Access Compliance Report

Public Rights-of-Way

Intersection ID: 28584	Main Street: FALCONCREST_DR	Cross Street: HIGHLAND_CREEK_PY	Location:	N
ADA ID: C4D6F65F4E71	Ramp Type: BlendTrans1	Initial Pass/Fail: Pass	Overall Compliance: No	Severity Score: 20

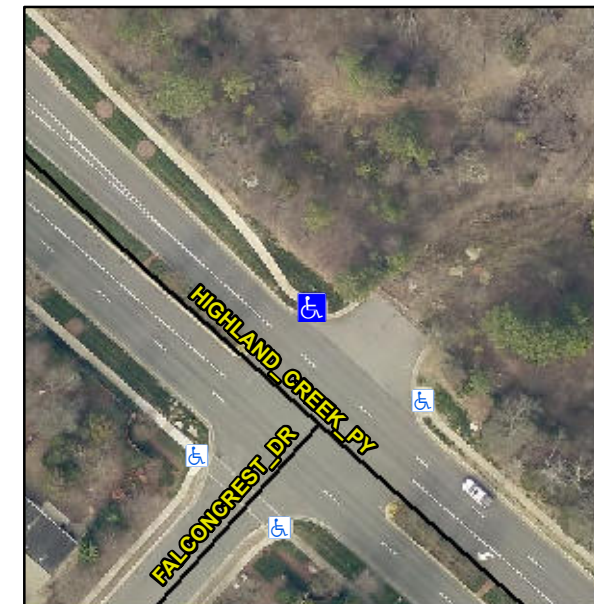
R304.2.2-Perp, R304.3.2-Para, R305.2, R302.7.2, R304.5.4

Compliance	Description	Data	Compliance	Description	Data
N/A	Ramp Length (in)	47.0	Yes	BlendTrans Slope (%)	1.1
Yes	Ramp Width (in)	59.5	Yes	BlendTrans XSlope (%)	1.1
N/A	Flare Type LT	Sloped	N/A	Flare Type RT	Sloped
N/A	Flare Slope LT (%)	0.7	N/A	Flare Slope RT (%)	1.6
N/A	Flare Traversable LT?	No	N/A	Flare Traversable RT?	No
Yes	Landing Length (in)	60.0	Yes	DWS Provided?	Yes
Yes	Landing Width (in)	50.0	Yes	DWS Contrast?	Yes
No	Landing Slope (%)	4.1	Yes	DWS Length (in)	25.5
Yes	Landing X Slope (%)	0.9	Yes	DWS Full Width?	Yes
N/A	Landing Curb? (Y/N)	No	No	DWS Offset (in)	3.0
N/A	Shared Landing?	No			
Yes	Gutter Ponding?	No	No	Gutter Slope (%)	7.0
No	Gutter Lip Ht (in)	2.0	Yes	Gutter X Slope (%)	1.4
N/A	Painted X Walk1?	No	N/A	Painted X Walk2?	No
	X Walk 1 Direction	To SW		X Walk 2 Direction	To SE
	X Walk 1 Width (in)	N/A		X Walk 2 Width (in)	N/A
	X Walk 1 Slope (%)	1.8		X Walk 2 Slope (%)	0.0
	X Walk 1 X Slope (%)	0.7		X Walk 2 X Slope (%)	0.2

N/A	Ramp inside XWalk1?	N/A	N/A	Ramp inside XWalk2?	N/A
	Road Slope (%)	0.0		Clear Space?	Yes
	Road X Slope (%)	1.9	N/A	Clear Space to XWalk (in)	N/A
Yes	Any Obstructions?	No	Yes	Storm Grate/Utility Hazard?	No
	Obstruction Type			Storm Grate/Utility Type	
		N/A			N/A
			Yes	Surface Condition? (G/P)	Good
			Yes	Curb Slope (%)	2.8

Remove & Replace Curb Ramp With Two New Directional Ramps or Equivalent. Remove & Replace Gutter.
